MFN 06-308

**Subject: Response to NRC Request for Additional Information Letter No. 51
Related to ESBWR Design Certification Application – Classification
of Structures, Systems and Components – RAI Numbers 3.2-1
through 3.2-62**

**GE Responses to NRC Request for Additional Information
Letter No. 51 for the ESBWR Design Certification Application
Classification of Structures, Systems and Components
RAIs 3.2-1 through 3.2-62**

Figure 3.2-1. Quality Group and Seismic Category Classification Applicable to Power Conversion System

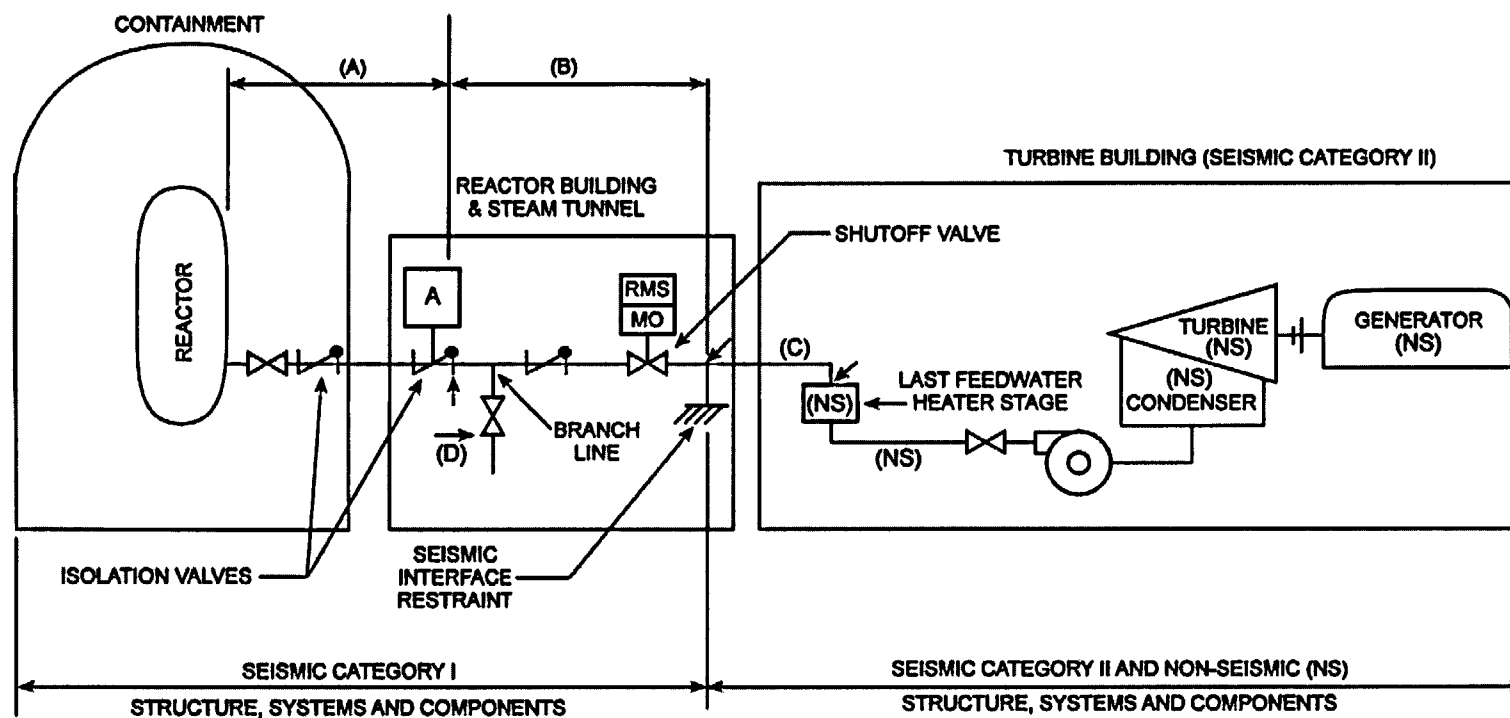
In accordance with SRP 3.2.2 and RG 1.26 guidance, the condenser anchorage and piping inlet nozzles to the condenser should be seismically analyzed. Therefore, this portion of the main steam system should be designated at least Quality Group D, Quality Assurance E, and Seismic Category II. Please revise Table 3.2-1, Component B21 accordingly.

In accordance with SRP 3.2.2 and RG 1.26 guidance, the steam lines connected to main steam lines from the power cycle auxiliary equipment including auxiliary steam shut off valves should be Quality Group D. Therefore, this portion of the main steam system should be designated at least Quality Group D, Quality Assurance E, and Seismic Category NS. Please revise Table 3.2-1, Component B21 accordingly.

Table 3.2-1, Component N37: The Table note for the Turbine Bypass System (TBS) states that only TBS lines equal to or larger than 63.5 mm (2.5 inches) are designed to ASME Section III, Class 2. However, the SRP 3.2.2 guidance states that all piping in the TBS lines up to the turbine bypass valves should be ASME Class 2 (Quality Group B). Beginning at the turbine bypass valve and downstream to the condenser, the line may be Quality Group D, as provided in SRP 3.2.2. Also, since the TBS is seismically analyzed, it should be designated at least as Seismic Category II. Please revise the Table accordingly.

Table 3.2-1, Component N61: The Table provides a Quality Assurance E and Seismic Category NS designation for the Main Condenser and Auxiliaries. However, the condenser is described in Section 15.4.4.5.2.4 as a Seismic Category II component. Consistent with guidance provided in SRPs 3.2.1 and 3.2.2 and RGs 1.26 and 1.29 for main steam leakage control, these components should be designated Quality Assurance B and Seismic Category II. Please revise the Table accordingly.

Figures showing the classification boundaries for the main steam and feedwater piping outside containment will be added to the DCD as Figures 3.2-1 and 3.2-2. See attached DCD markup for these figures.

The Main Condenser has a Nonsafety-related, Non-seismic design classification, but the inlet piping, inlet nozzles and condenser anchorage are seismically analyzed for SSE. Quality Groups and Seismic Classification will be shown on Figure 3.2-1, which will be added to the DCD.

Lines downstream of the seismic restraint shown in Figure 3.2-1 are classified as system N11, N61 or N33 (for example) on the P&ID. Therefore in DCD Table 3.2-1, B21 will not be updated. Quality Group and Seismic Classifications are shown on Figure 3.2-1 for the power cycle auxiliary equipment and shutoff valves.

The references to 63.5 mm (2.5 inch) will be removed for compliance to Regulatory Guide 1.26, Section C and Table 1. The wording will be revised to reflect Regulatory Guide 1.29 Section C, specifically item "1e", piping 2.5 inches and larger will be analyzed to withstand SSE loads. Quality Group and Seismic Classification will be shown in Figure 3.2-1.

The Condenser has a nonsafety-related, non-seismic design classification, but the Condenser anchorage is seismically analyzed for SSE. Quality Groups and Seismic Classification will be shown on Figure 3.2-1 for clarification. Since Quality Assurance requirements for the Main Condenser is not specifically addressed in the regulation, it will be determined during the detail design phase.
